UNITED STATES PATENT AND TRADEMARK OFFICE

APPLICATION NO.	FILING DATE	FIRST NAMED INVENTOR	ATTORNEY DOCKET NO.	CONFIRMATION NO.
09/943,029	08/29/2001	Sang-Hyun Lee	19570-05384	9521
22918	7590	06/15/2005	EXAMINER TORRES, JUAN A	
PERKINS COIE LLP P.O. BOX 2168 MENLO PARK, CA 94026			ART UNIT 2631	PAPER NUMBER

Office Action Summary	Application No.	Applicant(s)	
	09/943,029	LEE ET AL.	
	Examiner	Art Unit	
	Juan A. Torres	2631

DETAILED ACTION

FIG. 1

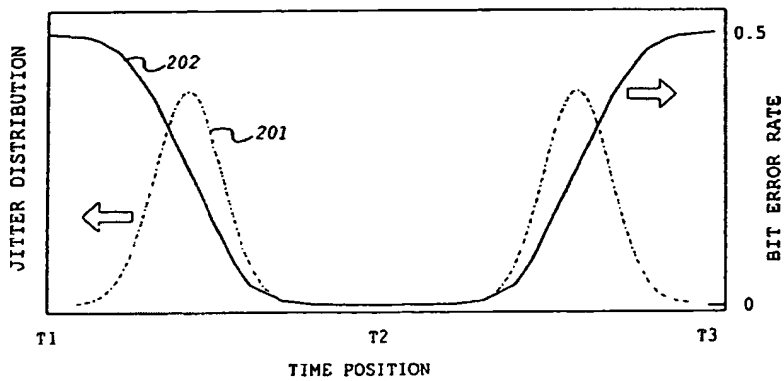
Figures 1 and 2 should be designated by a legend such as –Prior Art– because only that which is old is illustrated. See MPEP § 608.02(g). Corrected drawings in compliance with 37 CFR 1.121(d) are required in reply to the Office action to avoid abandonment of the application. The replacement sheet(s) should be labeled “Replacement Sheet” in the page header (as per 37 CFR 1.121(d)) so as not to obstruct any portion of the drawing figures. If the changes are not accepted by the examiner, the applicant will be notified and informed of any required corrective action in the next Office action. The objection to the drawings will not be held in abeyance.

"PRIOR ART"

"PRIOR ART"

FIG. 6

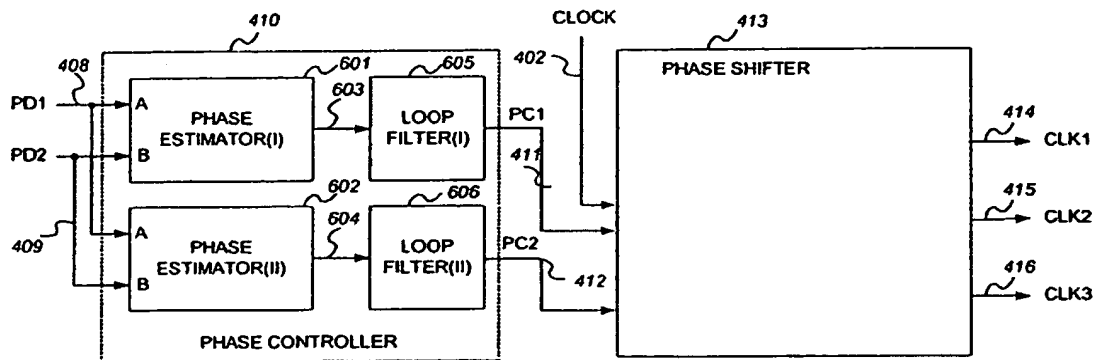
The drawings are objected to because FIG. 6 and FIG. 9 have not been printed correctly (it seems that the printer didn't have enough memory and some details that are in the original graphic have not been printed in the hardcopy, sometimes this problem can be fixed reducing the quality of the graphic at the time of printing). FIG. 6 is objected because: line 415 is not shown. FIG. 9 is objected because: Line 911 is not shown; line connecting block 911 with block 909 is not shown; line connecting block 901 with block 903 is not shown; line connecting label 903 with block "PHASE DISTRIBUTOR" is not shown. Corrected drawing sheets in compliance with 37 CFR 1.121(d) are required in reply to the Office action to avoid abandonment of the application. Any amended replacement drawing sheet should include all of the figures appearing on the immediate prior version of the sheet, even if only one figure is being amended. The figure or figure number of an amended drawing should not be labeled as "amended." If a drawing figure is to be canceled, the appropriate figure must be removed from the replacement sheet, and where necessary, the remaining figures must be renumbered and appropriate changes made to the brief description of the several views of the drawings for consistency. Additional replacement sheets may be necessary to show the renumbering of the remaining figures. The replacement sheet(s) should be labeled "Replacement Sheet" in the page header (as per 37 CFR 1.84(c)) so as not to obstruct any portion of the drawing figures. If the changes are not accepted by the

The drawings were received on 05/02/2005. These drawings are accepted by the Examiner.

FIG. 7

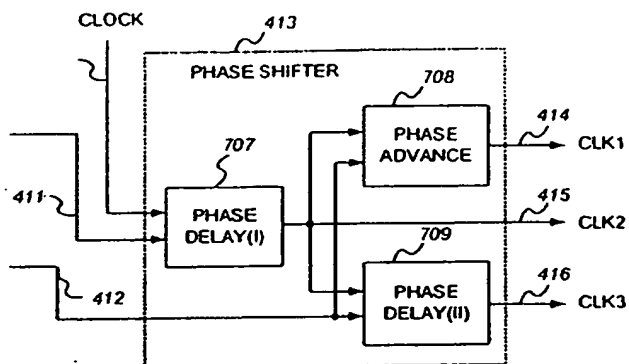
Page 13 paragraph [0033] line 3 block 411 is not shown in FIG. 7.
